citizenM Hotel
201 Westlake Ave N

SDCI Project # 3023379

Design Review Board
West Design Review Board

Date: September 6, 2017

Level 1 Plan with Requested Departure to Required Street-Level Uses

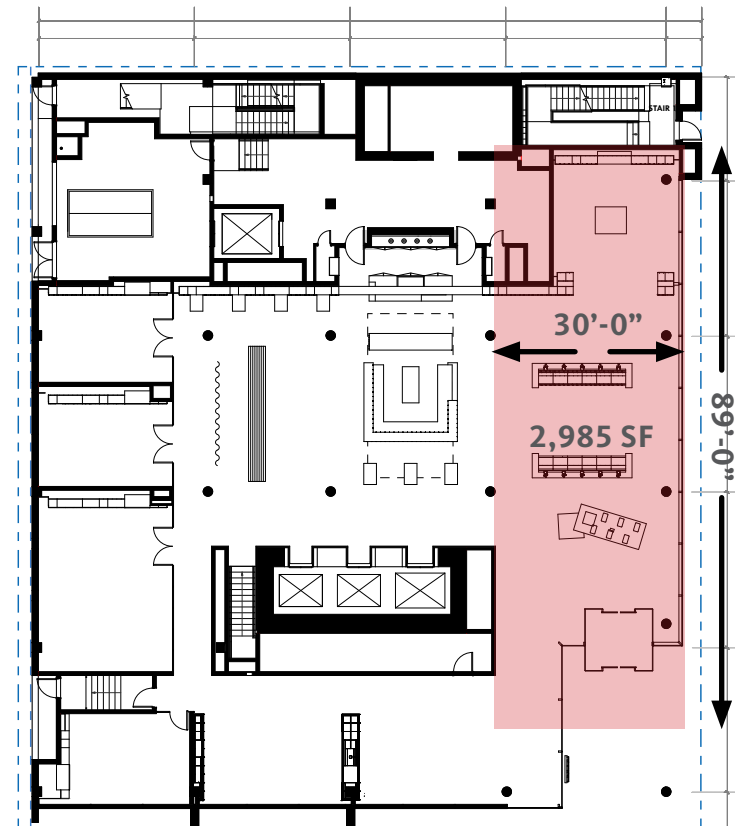
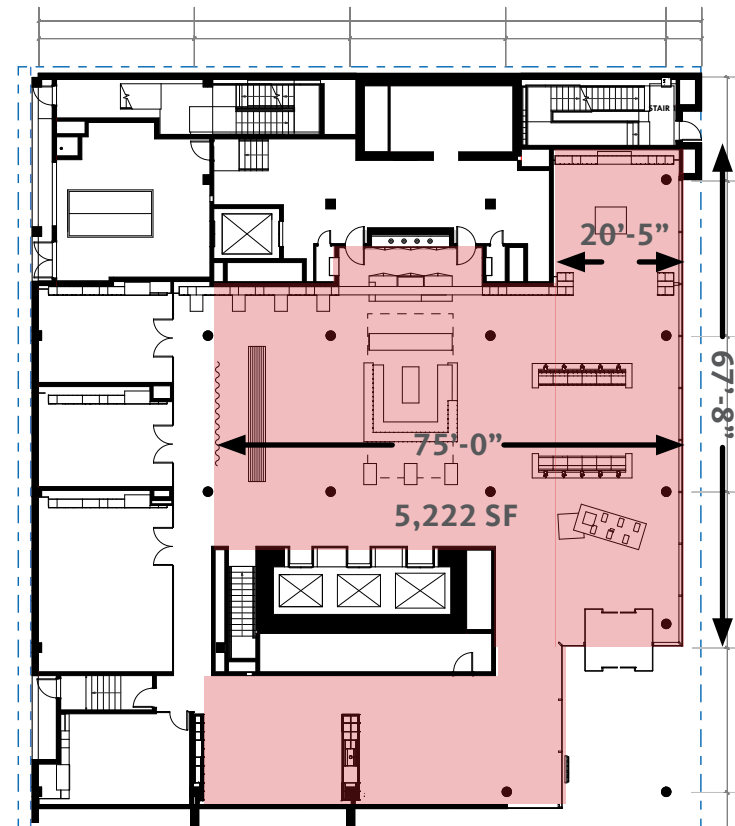
SMC 23.48.040.C1 requires qualifying street level uses along 75% of the Westlake Ave facade, which amounts to 89'. The applicant proposes street level uses for 57% along Westlake Ave for a length of 67'-8".

- Due to the compact nature of the site, the substantial elevator core wall dimensions and the planning of the back of house areas and per SMC 23.41.012.B.2, the design team seeks a departure to allow a reconfigured street-level uses meeting the intent of the code, if not the letter.

- Along Westlake Avenue, 89'-0" of street-level use is required. Here, the team proposes a street-level use length of 67'-8". Due to interior planning requirements, the depth of this use varies. In much of the area, the depth is much greater than the required 30'

BOARD DIRECTION

- The Board recommended approval of the departure request as the depth and openness of the lounge area allows for layers of the activities to occur. The Board also found the extended storefront height maximizes the amount of ground level transparency to connect to the pedestrian realm. The resulting design better meets Design Guidelines CS2-B-2 Connection to the Street and PL3-C-1 Porous Edge and opportunities to visually interact are upheld.

Level 1 Plan with Requested Required Street-Level Development Standards

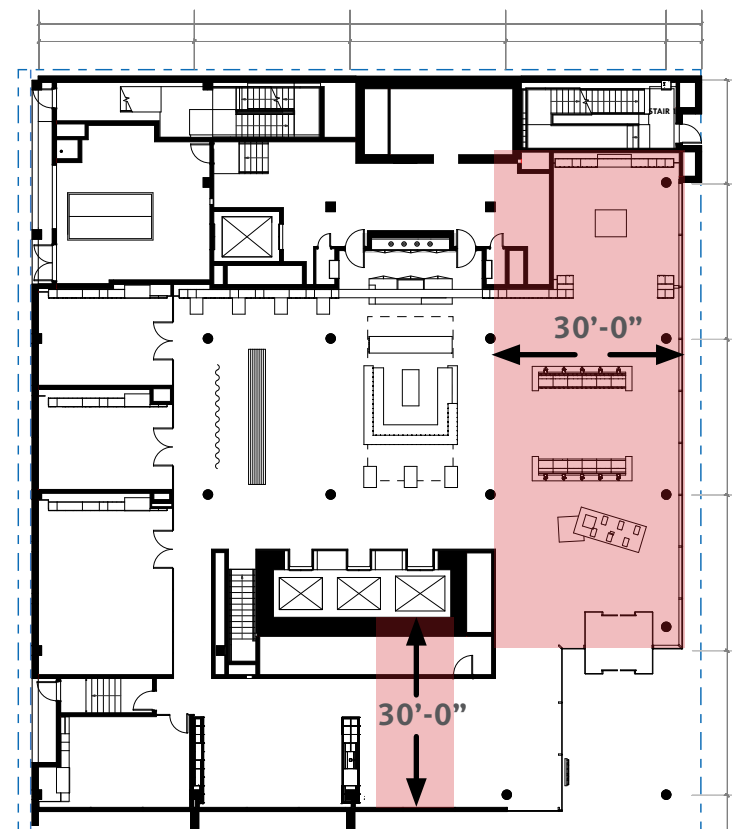
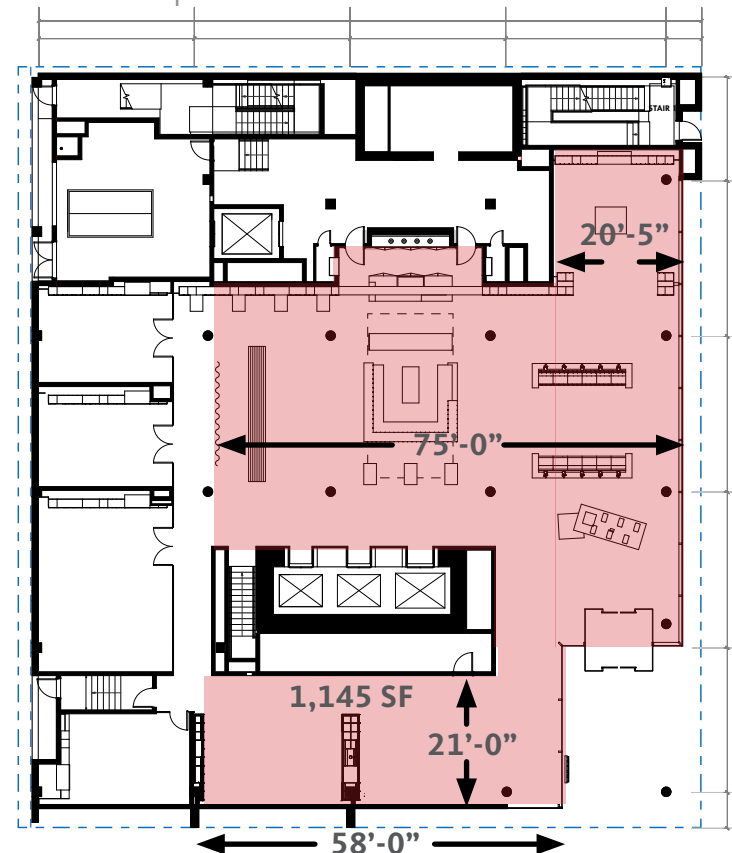
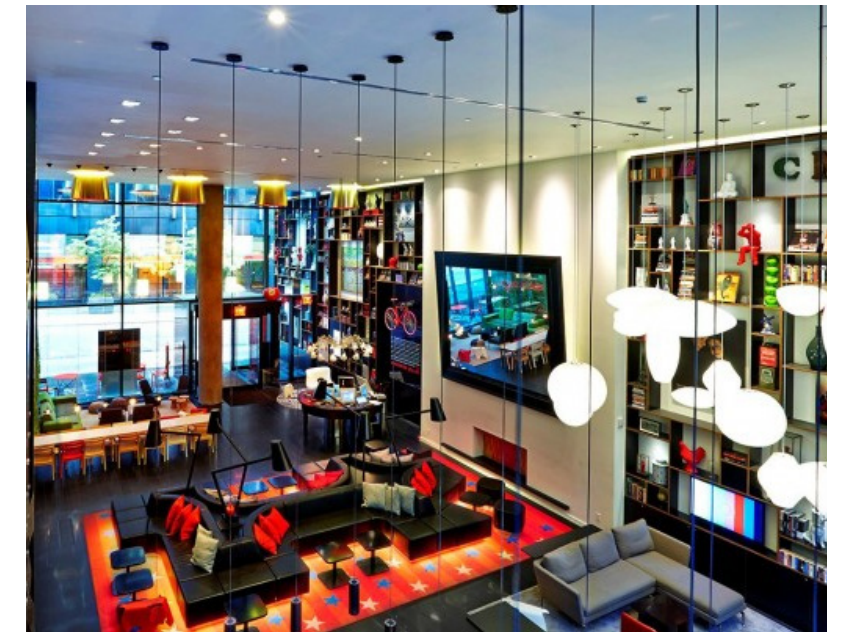
SMC 23.48.040.C3 requires a non-residential depth to be at least 30'. The applicant proposes a 20'-5" interior depth for a portion of the Westlake Ave facade and 21' interior depth for the John St facade.

- Along Westlake Avenue, 89'-0" of street-level use is required. Here, the team proposes a street-level use length of 67'-8". Due to interior planning requirements, the depth of this use varies. In much of the area, the depth is much greater than the required 30'.
- Along John Street, 10'-6" of street-level use is required. Here the team proposes a street-level use length of 58'-0". While the provided length is much larger than the requirement, the depth is only 20'-11". In total, approximately 1,145 SF of space is provide here, far greater than the 315 SF required.

BOARD DIRECTION

- The Board recommended approval of the departure, provided the central meeting room along John is omitted for additional open lounge space. The resulting design locates more active spaces along John than required by code and the potential to better activate the pedestrian realm and transition to the sidewalk along Westlake Ave. The resulting design better meets Design Guidelines DC1-A Arrangement of Interior Uses and PL3-C-1 Porous Edge, subject to the conditions listed at the end of this report.

Departure Request: SMC 23.48.040.C Required Street-Level Uses along Class I Pedestrian Streets

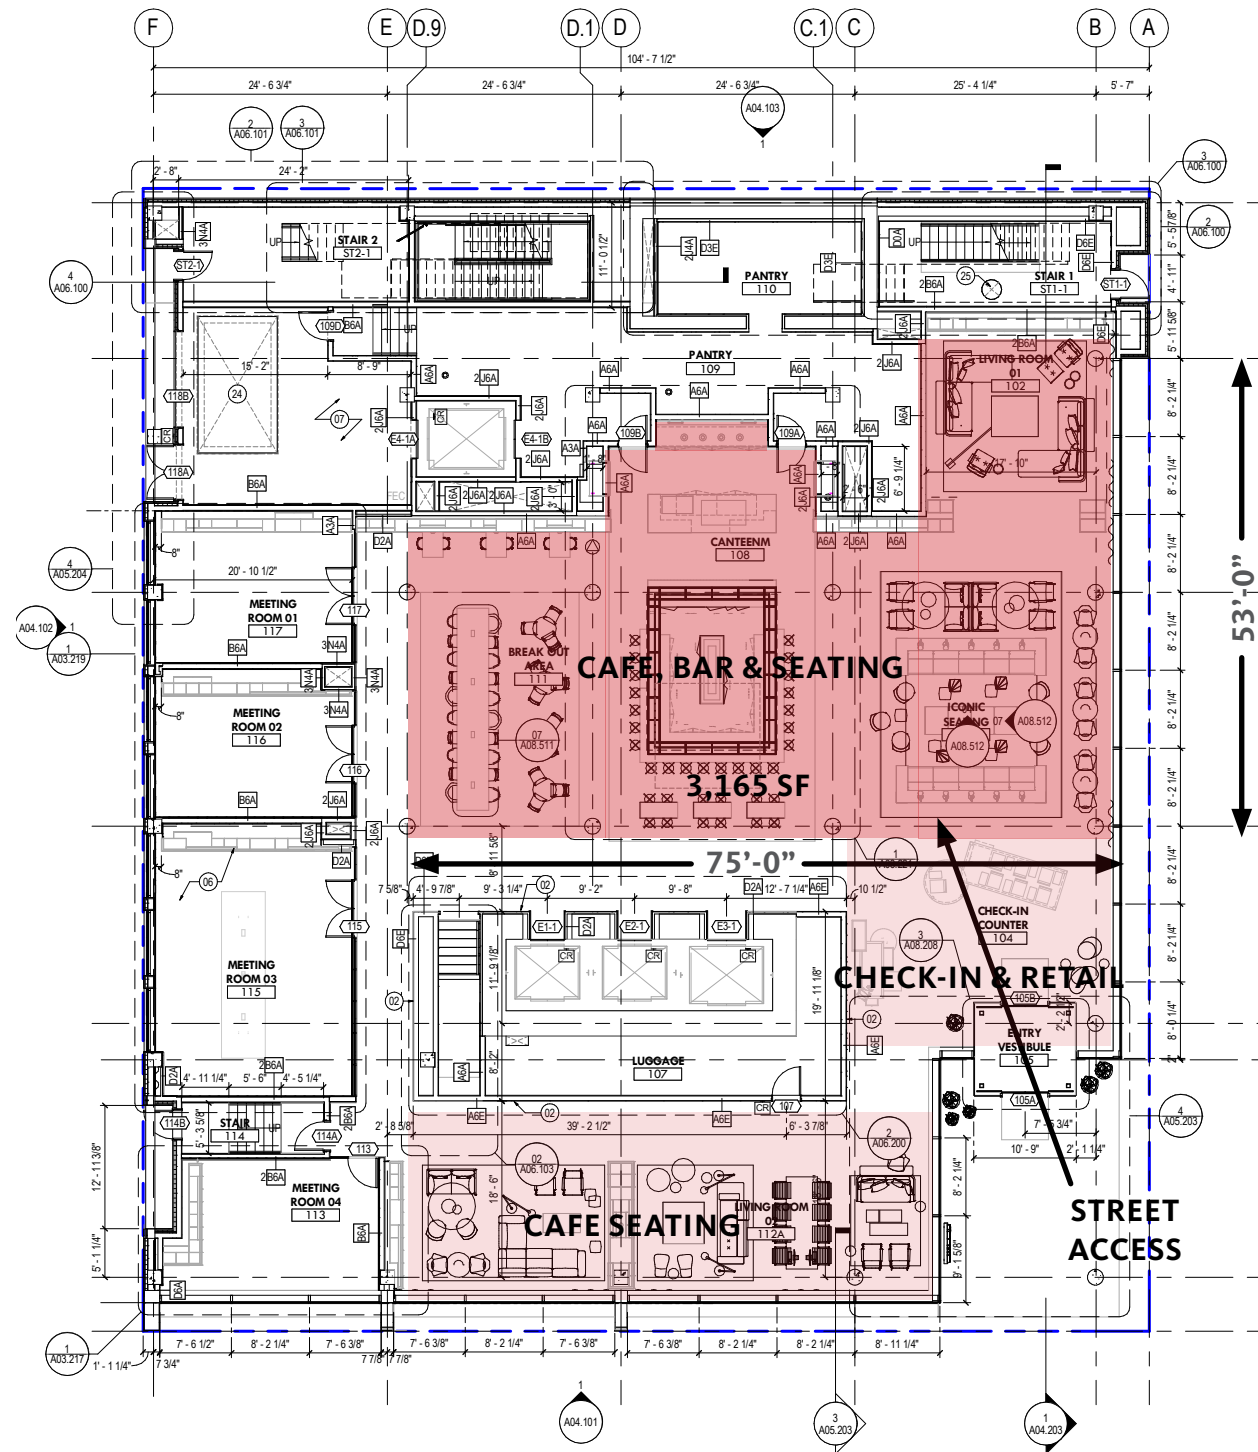
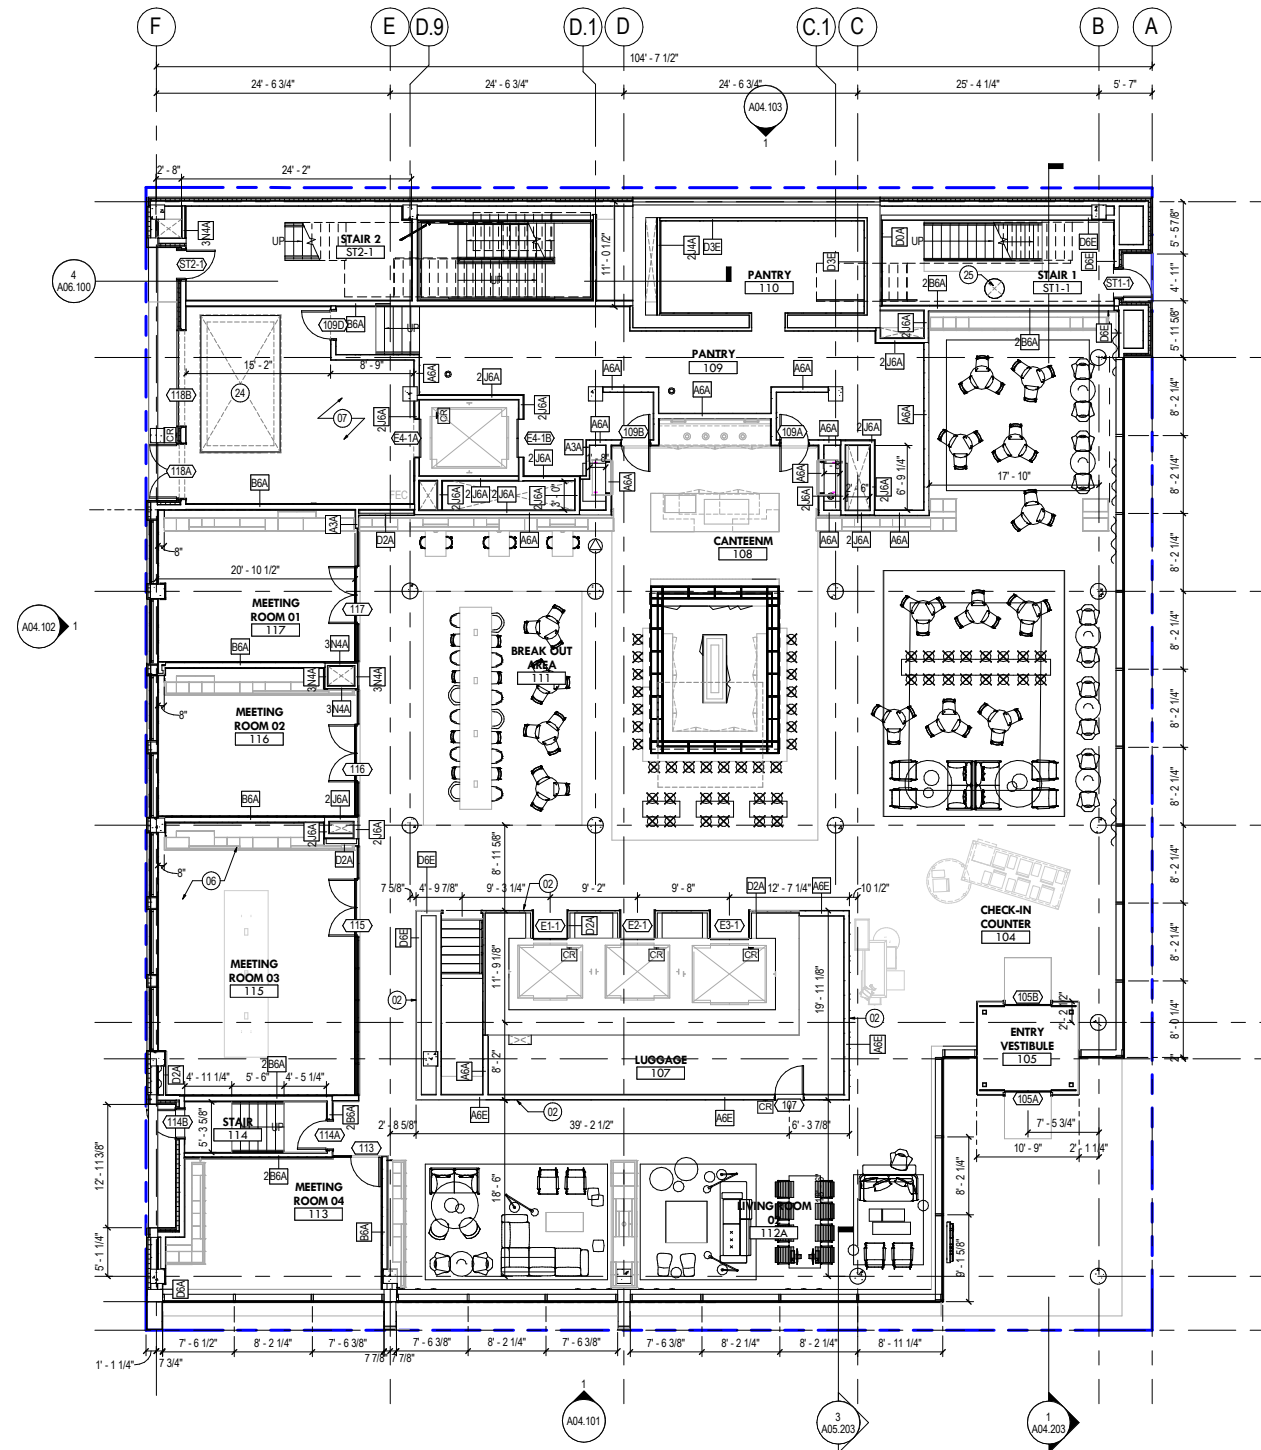
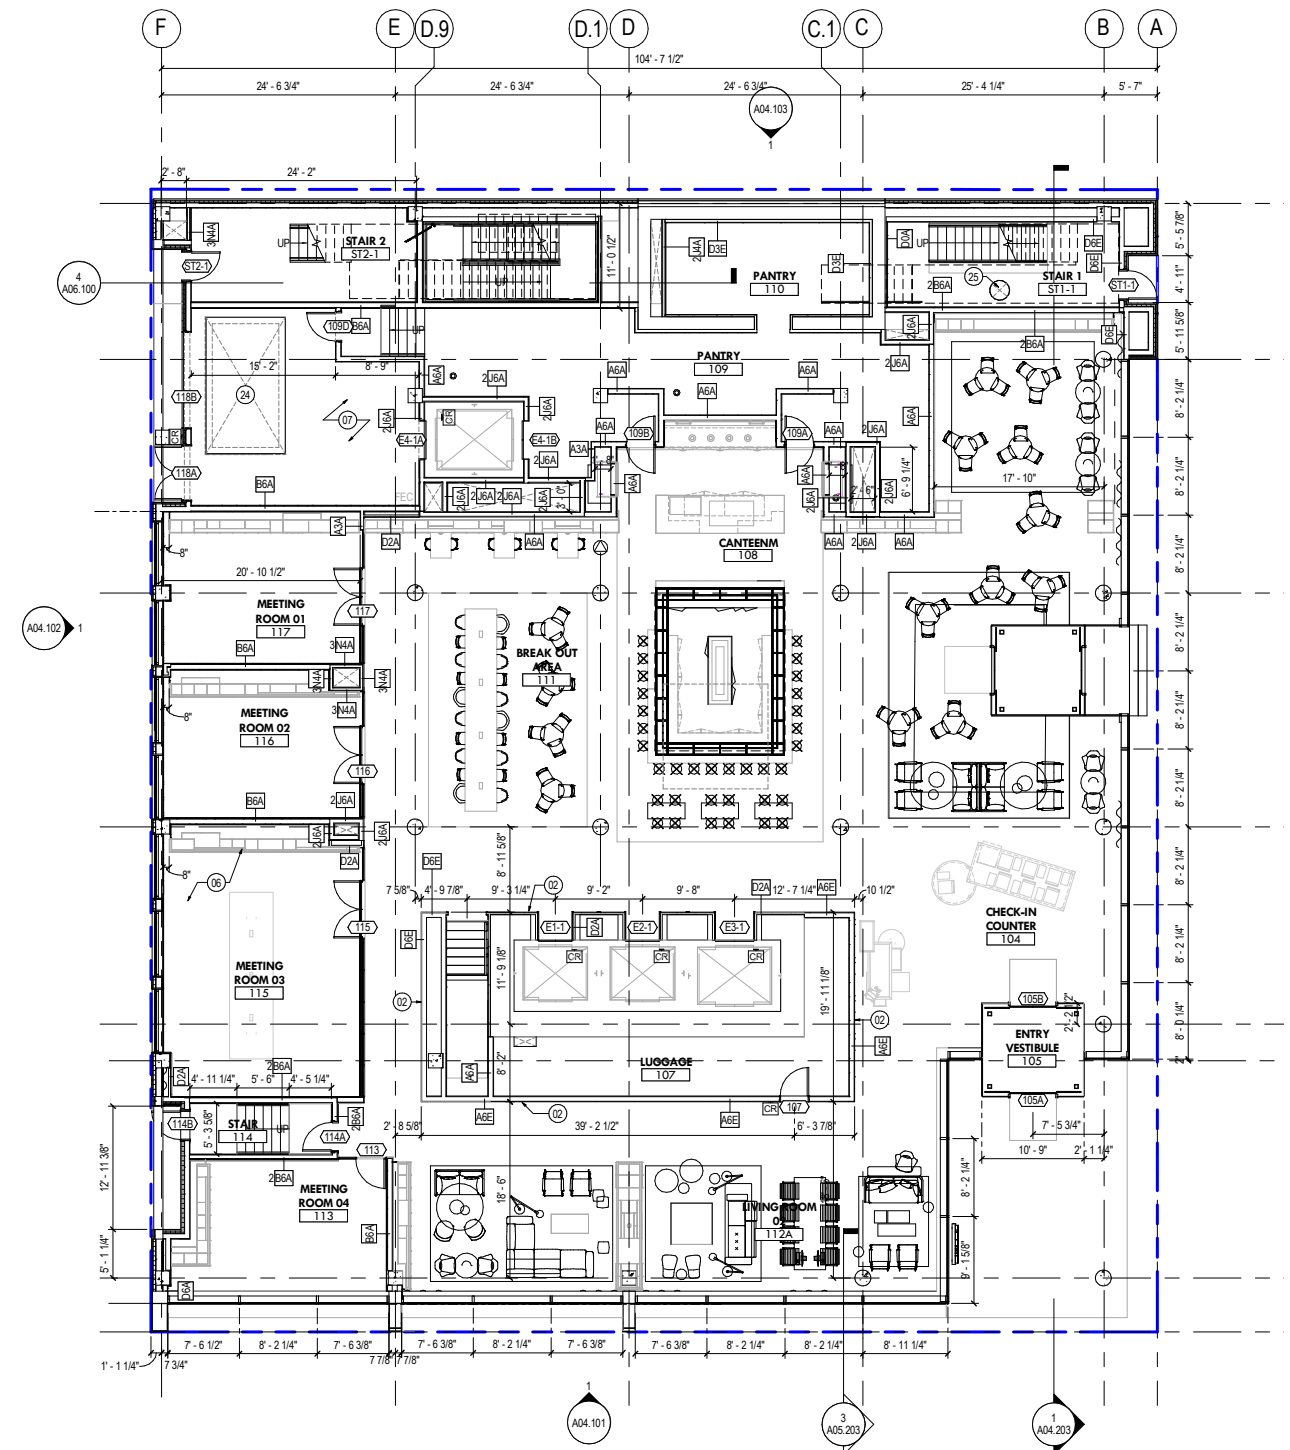
Along Westlake Avenue N (Class 1), provide 0 linear feet of street level use complying with SMC 23.48.005.D.1.

The hotel's canteenM (cafe) and bar along with its seating areas comprises a total of 3,165 SF. The required size of the required street-level use (30' deep by 67'-8") is 2,030 SF. The volume of space is considerably larger than would be required due to the 15' clear ceilings.

Public area spaces within a citizenM Hotel are not technically hotel spaces. They are food and beverage spaces akin to a cafe or coffee shop and they provide very active spaces along street frontage. This is in keeping with the spirit of the street-level use requirement.

- Cafe seating is more typical of a food-only establishment, but not a cafe

- Vestibule directly from Westlake disrupts the street frontage and runs counter to the spirit of the street level use
